May 9, 2025

Re: Comments on Draft Permit IN0000108, BP Products North America Inc. – Whiting Refinery

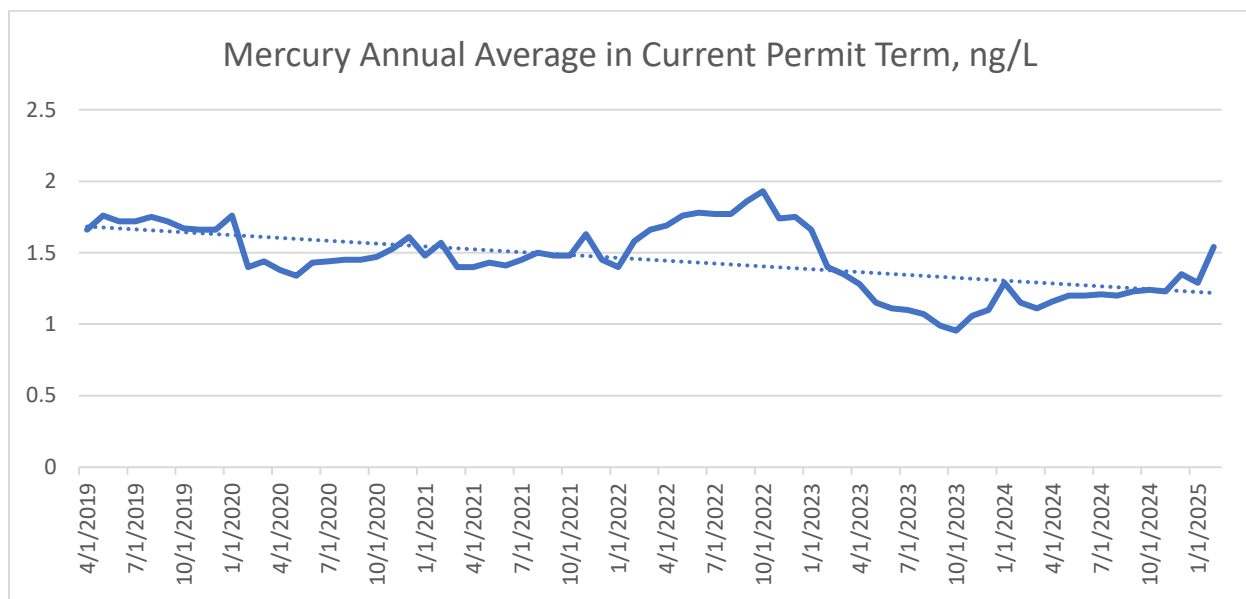
Based on the mercury samples in this permit term, BP’s current PMPP has not achieved progress towards the goal of reducing mercury. Since the current permit became effective on April 1, 2019, there has been no reduction in daily mercury concentrations—in fact, the trendline indicates a slight increase. Attachment 1, BP Whiting DMR Data.

Moreover, there has been almost no reduction in BP’s annual average mercury samples—the January 2025 annual average of 1.54 ng/L is almost exactly the same as the April 2019 annual average of 1.6 ng/L.
